PSE Power Control SM for SS PDs

PSE Power Control SM for DS PDs

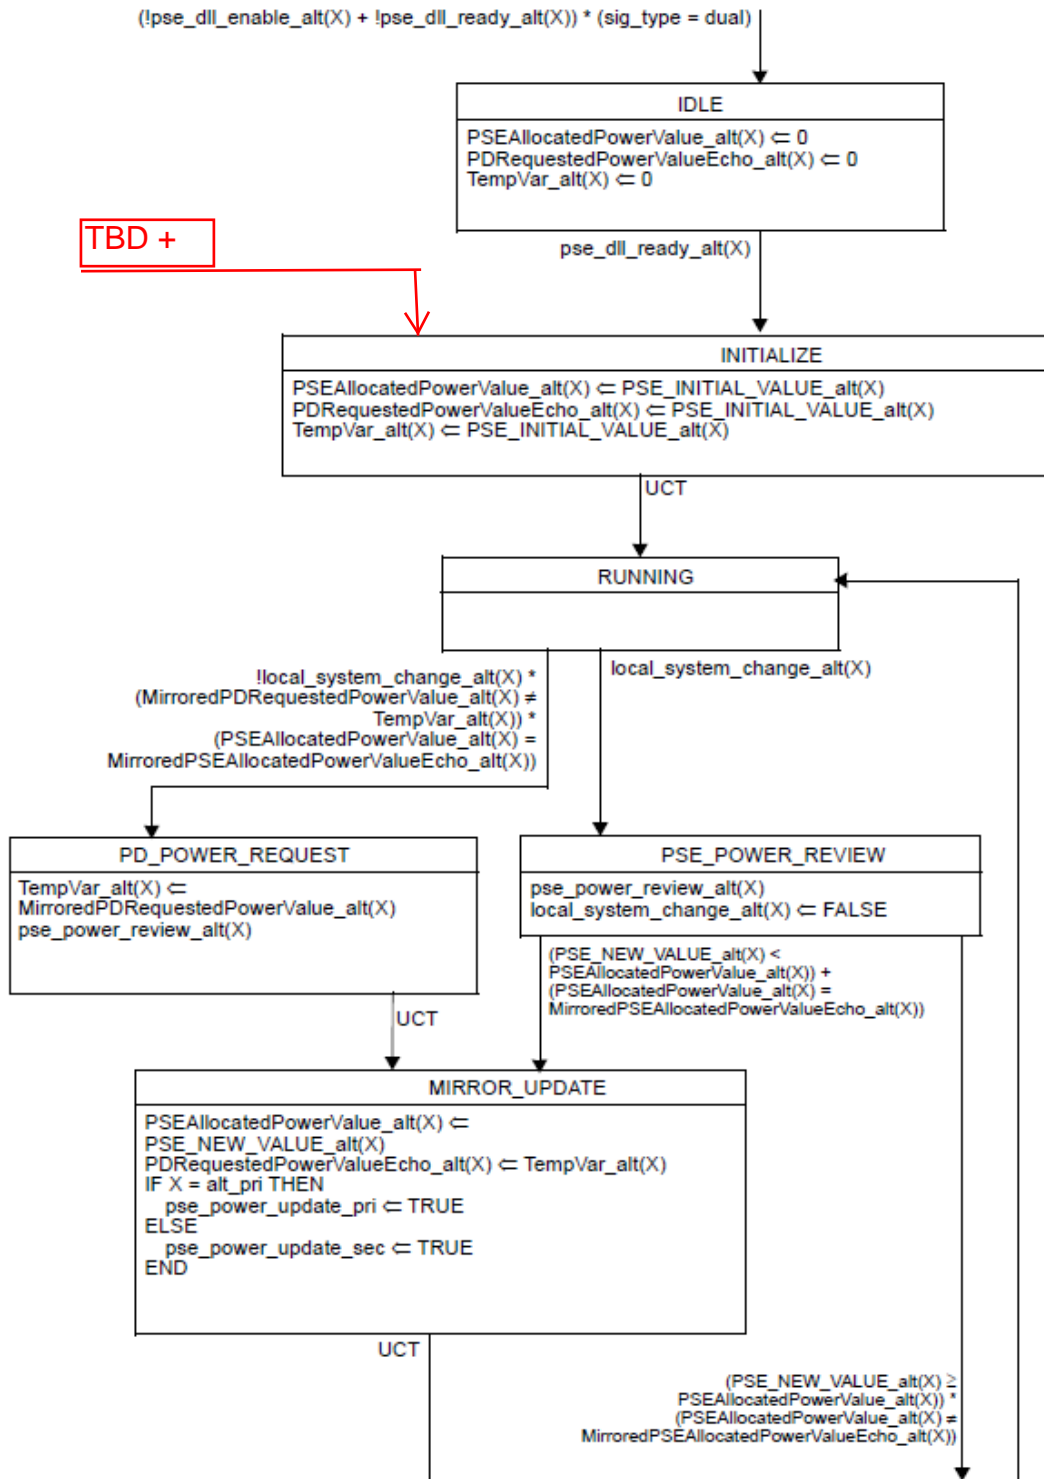
- 1) A Dual signature PD is powered over 2 pairs ✓
- 2) A PD_POWER_REQUEST is in progress ✓
 - a. TempVar and MirroredPDRequestedPowerValue are in use ✓
- 3) A transition to 4 pair power occurs ✓
- 4) Suddenly the alt_x versions are in force ✓
- 5) How does the state to state mapping occur when jumping from state machine to state machine? ✓

See following state machines for reference.

Yair: Answer to (5):

At the INITIALIZE or the IDLE state (depend on the SM), we will have input $(!pse_dll_enable_alt(X) + !pse_dll_ready_alt(X)) * (sig_type = dual) + TBD$, that when TBD is TRUE, it will initiate a function that will fill in the TLVs correctly, and will switch to the other state machine so the status of the internal variables of the previous state machine will not be important since the process (power negotiation) will start again based on the new conditions and last informations from the previous state machine

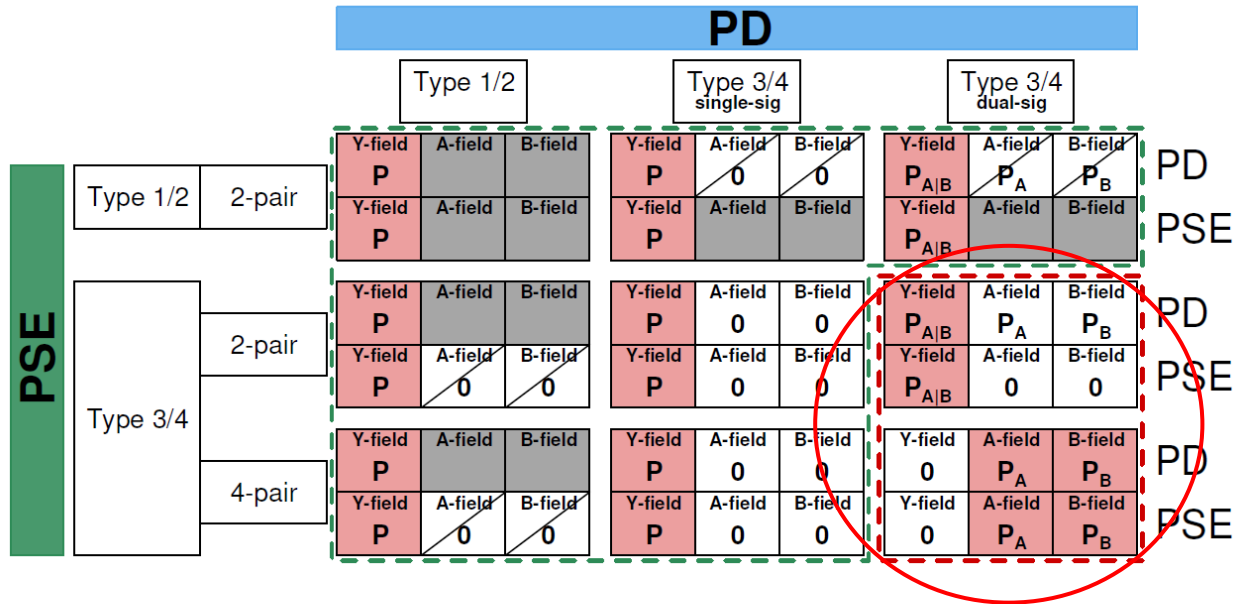
Instead is there a way to provision the SMs for DS PDs so state machine don't need to be laboriously glued together?

The root problem seems to lie in one particular set of cells in Lennart's proposal:

Can all states which assign power or mirrored power get the following additional logic:

If (X == A)
  If (pairsx == both)
    Y = 0
  else
    Y = A
Else
  If (pairsx == both)
    Y = 0
  else
    Y = B

Yair: How this logic works. Where is the END or Ends of this function?
